Complied 2015 Meeting Minutes

WSDOT/AGC/ACEC Design-Build Committee

# WSDOT/AGC/ACEC DESIGN-BUILD TEAM MEETING

Figure 2.1 Determination of Probable and Final PDM as part of Project Development Phases Flowchart

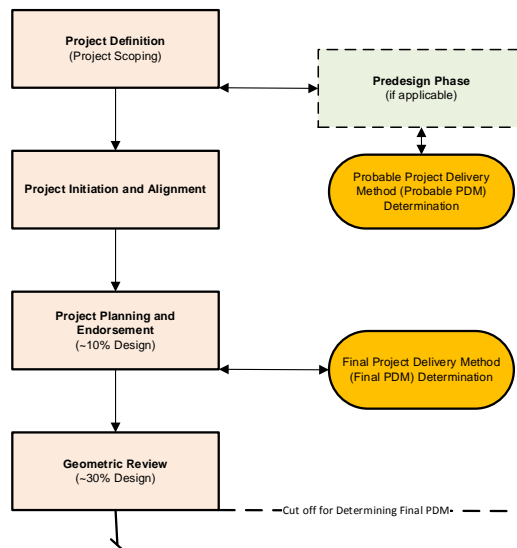
**Comment [ET22]:** Bob Adams says: 2.1.2, page 12, graphic foot note. 30% should not be a cut-off for Determining Final PDM

**Same as above**

**Figure 3.1 Probable PDM Determination Flowchart**

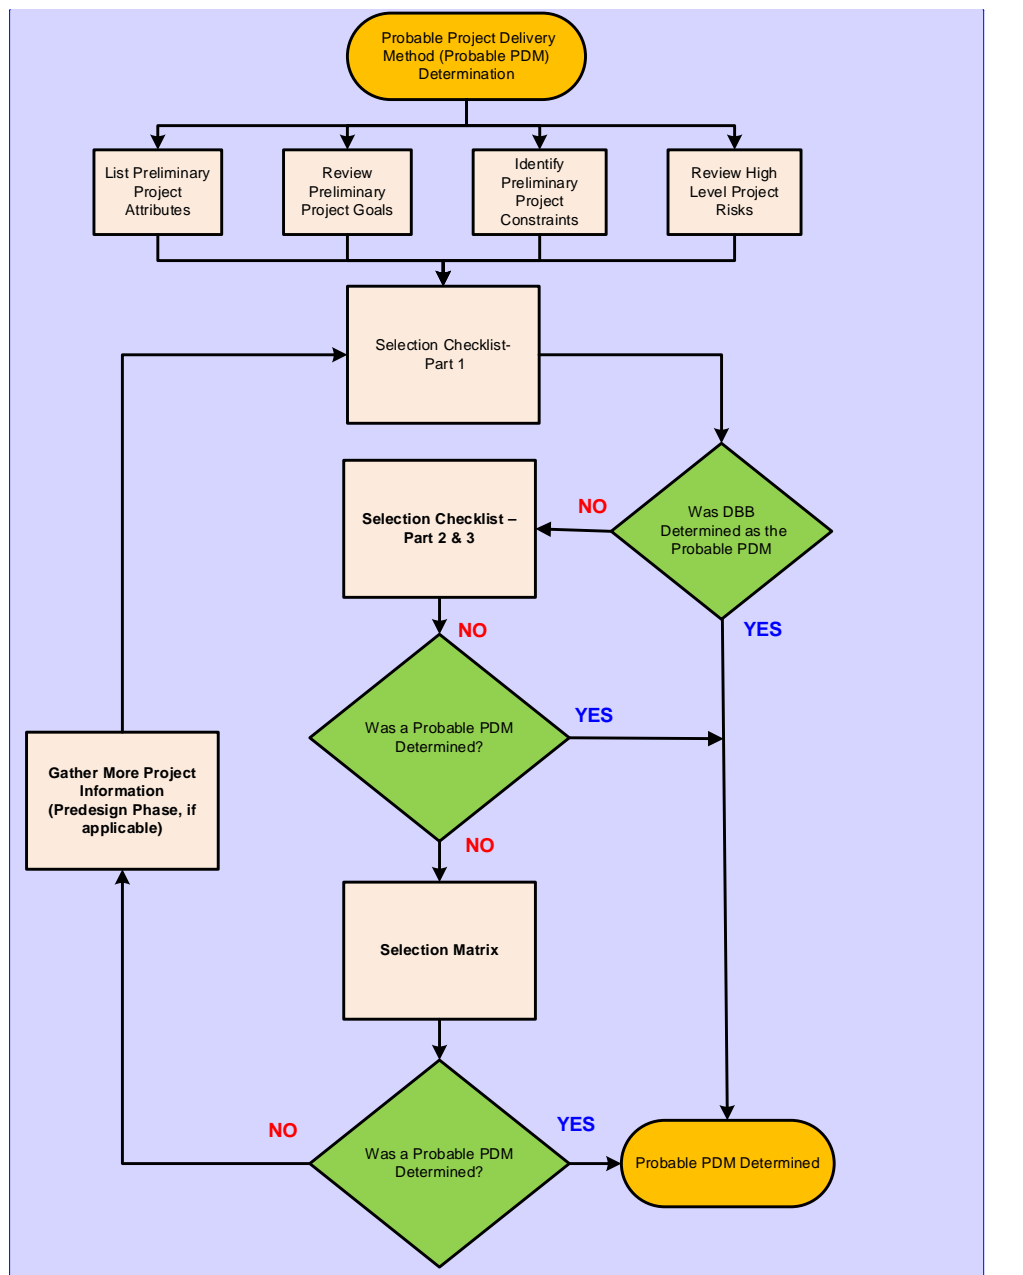
**Comment [ET33]:** Bob Adams says: Figure 3.1 Flowchart. This chart assumes DBB as the default Probable PDM. Why not assume DB as the default, as encouraged by the legislature?

Figure 4.1 Final PDM Determination - Validation/Revision Process Flowchart

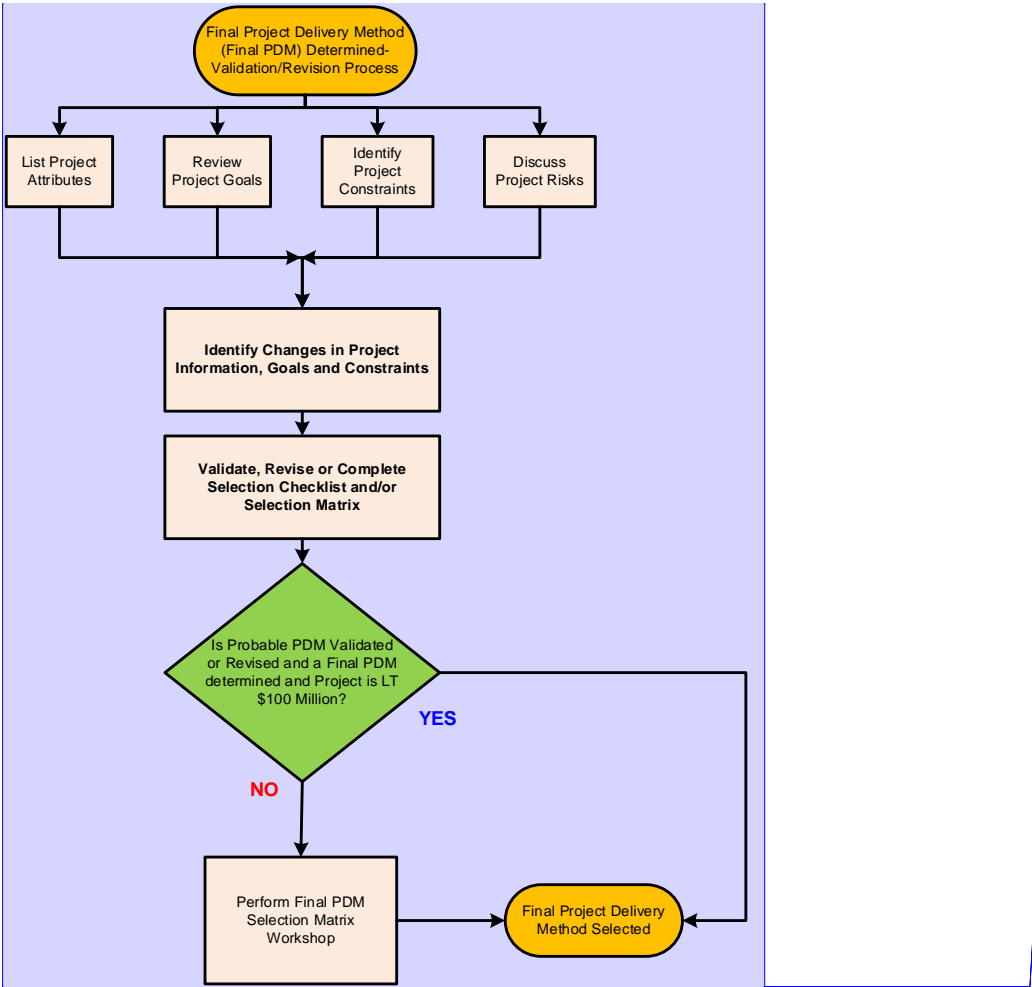
**Comment [ET40]:** Lisa Hodgson:  
Green triangle has "LT" - think this was  
supposed to be "Less Than"?  
**Resolution -** Yes - will review and revise  
as needed.
